**BOARD OF ZONING ADJUSTMENT
STAFF REPORT****Date: January 9, 2012****CASE NUMBER**

5725

Zion Baptist Church

LOCATION2514 Halls Mill Road
(Northwest corner of Halls Mill Road and Pollard Lane)**VARIANCE REQUEST****SURFACING:** Surfacing Variance to allow a grass parking area for a church in an R-1, Single-Family Residential District.**ACCESS AND MANEUVERING:** Access and Maneuvering Variances to allow a 10'-wide asphalt drive.**PARKING RATIO:** Parking Ratio Variance to allow no designated parking spaces for a church.**ZONING ORDINANCE
REQUIREMENT****SURFACING:** The Zoning Ordinance requires parking areas to be paved with asphalt, concrete, or an approved alternative paving surface for a church in an R-1, Single-Family Residential District.**ACCESS AND MANEUVERING:** The Zoning Ordinance requires two-way drive aisles to be a minimum of 24' wide.**PARKING RATIO:** The Zoning Ordinance requires designated parking spaces equal to one space per four seats for a church.**ZONING**

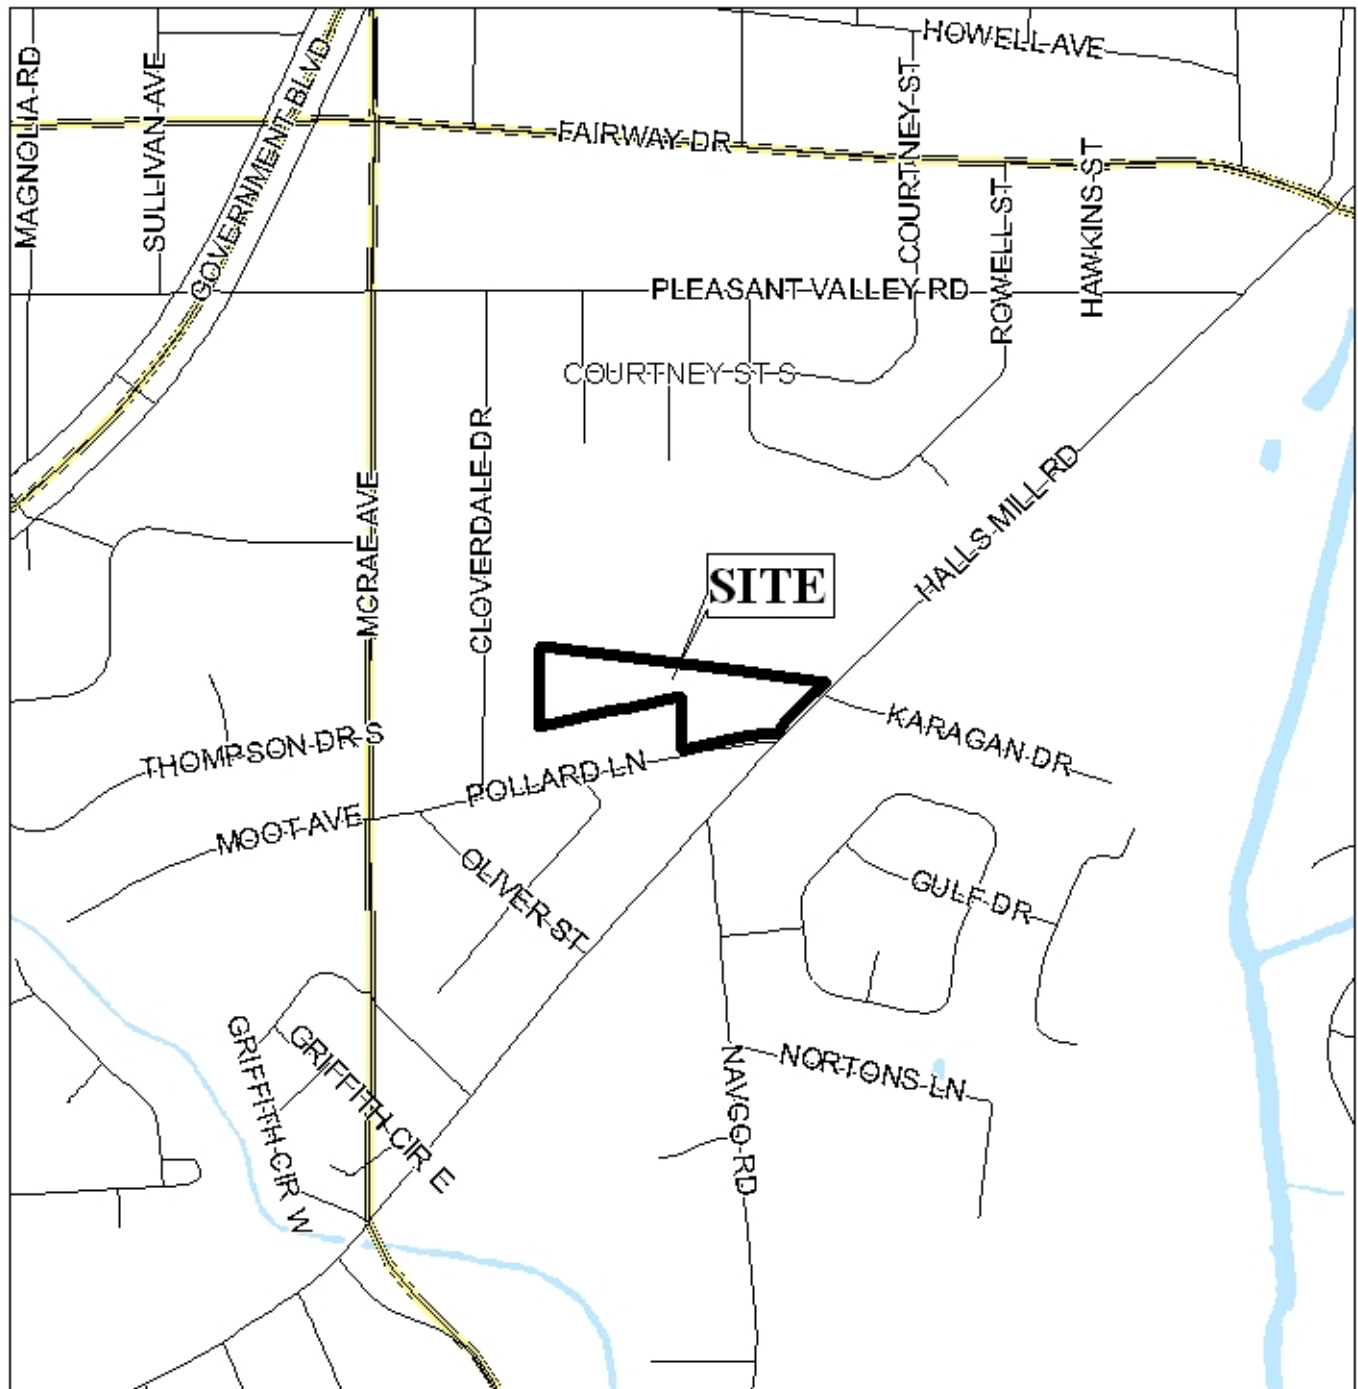
Revised for the January 9, 2012 meeting: Driveway number, size, location and design to be approved by Traffic Engineering and conform to AASHTO standards. As shown, the 10' asphalt drive is not wide enough to accommodate two-way traffic. A 14'-16' aisle is the minimum desirable width to designate an entrance as one-way. Also the gate at Halls Mill Road may prohibit circulation through the site if it is common

practice to keep the gate closed or locked. Two-way traffic cannot occur between the maintenance building and the church where there appears to be a clearance of only 10'. The building shows signs of being hit because of the unacceptable clearance. Parking stalls along Pollard Street are not accurately depicted in the site plan. Several of the "stalls" are less than 20' from the edge of the roadway. Any parking that requires backing into the right-of-way or parking within the right-of-way is not recommended. Excess asphalt and/or gravel surfaces within the right-of-way that are not permitted to be utilized as parking through a right-of-way use agreement should be removed. There is no existing designated handicap parking and the site plan does not show adequate facilities to account for handicap accessibility (for example, proper parking stall size, aisles and solid surface access to the structures).

Parking areas should be paved or stabilized to prevent erosion of the existing soil. Allowing vehicles to park on the grass tends to keep the most heavily used parking areas without cover, increasing the movement of sediment downstream. Existing site drains to the north, towards an existing offsite drainage ditch.

The site plan needs to be revised to indicate where the parking area currently is that is the subject of the Surfacing and Parking Ratio Variance requests. The revised site plan should also take into consideration concerns of the Planning Commission reports such as required street frontage dedication and adjusted 25' minimum building setback line, lighting, buffering and the provision of dumpster facilities. Also, landscaping and tree plantings should be shown along with the appropriate calculations. If other non-compliance beside the surfacing, access and maneuvering, and parking ratio are indicated on the revised site plan, this application should be revised to include such as variance requests with revised request fees and mail-out notification fees.

Finally, it should be pointed out that the Americans with Disabilities Act may require the provision of wheelchair accessible parking, which may consequently require some paving. The design professional should verify ADA parking requirements and revise the site plan accordingly.

A revised site plan and narrative have been submitted; however, some of the items of concern of the original site plan and narrative have not been addressed. Specifically, there is no illustration that a literal enforcement of the Zoning Ordinance will result in an unnecessary hardship, only a request that it be allowed to continue. The site has ample room to provide compliant paved parking spaces meeting the parking ratio requirements and ample room to provide compliant access/maneuvering area. The Traffic Engineering comments generally reflect staff's analysis of the site with regards to the continuation of the noncompliant aspects of the site's parking and access situation, especially in reference to the substandard drive widths and the access/maneuvering areas within the public right-of-way.

The Board should consider all three of the variance requests for denial as there has been absolutely no hardship illustrated as a basis for approval and the site has ample area to provide full compliance with all aspects of the surfacing, access/maneuvering, and parking ratio requirements of the Ordinance.

RECOMMENDATION: Based on the preceding, this application is recommended for holdover to the January 9, 2012, meeting, with revision due by December 19th, to allow the applicant to address the following items:

- 1) revision and clarification of the narrative to identify which site the variance requests pertain to and illustration of some hardship imposed by the property which would justify the granting of the requests;

- 2) revision of the site plan to illustrate which area the Surfacing and Parking Ratio Variance requests pertain;
- 3) revision of the site plan to take into consideration concerns of the Planning Commission reports such as required street frontage dedication and adjusted 25' minimum building setback line, lighting, buffering and the provision of dumpster facilities;

- 4) revision of the site plan to illustrate landscaping and tree planting areas along with the appropriate calculations;
- 5) revision of this application to also include any other non-compliant aspects of the revised site plan as additional variance requests with associated request fees and mail-out notification fees; and

- 6) revision of the site plan to comply with any parking requirements of the Americans with Disabilities Act.
